# Access Compliance Report

## Public Rights-of-Way

Intersection ID: N/A	Main Street: AGNEW_DR	Cross Street: SOLAR_WY	Location: SE
ADA ID: F615E56E7408	Ramp Type: BlendTrans1	Initial Pass/Fail: Fail	Overall Compliance: No
		Severity Score: 10

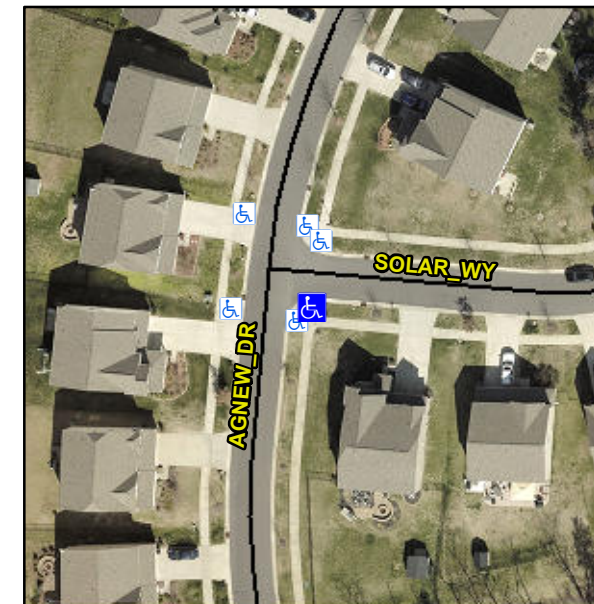
**R304.5.1, R304.5.3**

Compliance	Description	Data	Compliance	Description	Data
N/A	Ramp Length (in)	100.0	Yes	BlendTrans Slope (%)	2.9
No	Ramp Width (in)	44.0	No	BlendTrans XSlope (%)	2.6
N/A	Flare Type LT	N/A	N/A	Flare Type RT	N/A
N/A	Flare Slope LT (%)	N/A	N/A	Flare Slope RT (%)	N/A
N/A	Flare Traversable LT?	N/A	N/A	Flare Traversable RT?	N/A
N/A	Landing Length (in)	N/A	N/A	DWS Provided?	N/A
N/A	Landing Width (in)	N/A	N/A	DWS Contrast?	N/A
N/A	Landing Slope (%)	N/A	N/A	DWS Length (in)	N/A
N/A	Landing X Slope (%)	N/A	N/A	DWS Full Width?	N/A
N/A	Landing Curb? (Y/N)	N/A	N/A	DWS Offset (in)	N/A
N/A	Shared Landing?	N/A			
N/A	Gutter Ponding?	N/A	N/A	Gutter Slope (%)	N/A
N/A	Gutter Lip Ht (in)	N/A	N/A	Gutter X Slope (%)	N/A
N/A	Painted X Walk1?	No	N/A	Painted X Walk2?	N/A
	X Walk 1 Direction	To N		X Walk 2 Direction	N/A
	X Walk 1 Width (in)	N/A		X Walk 2 Width (in)	N/A
	X Walk 1 Slope (%)	3.5		X Walk 2 Slope (%)	N/A
	X Walk 1 X Slope (%)	0.4		X Walk 2 X Slope (%)	N/A

**Remove & Replace Curb Ramp With Two New Directional Ramps or Equivalent.**
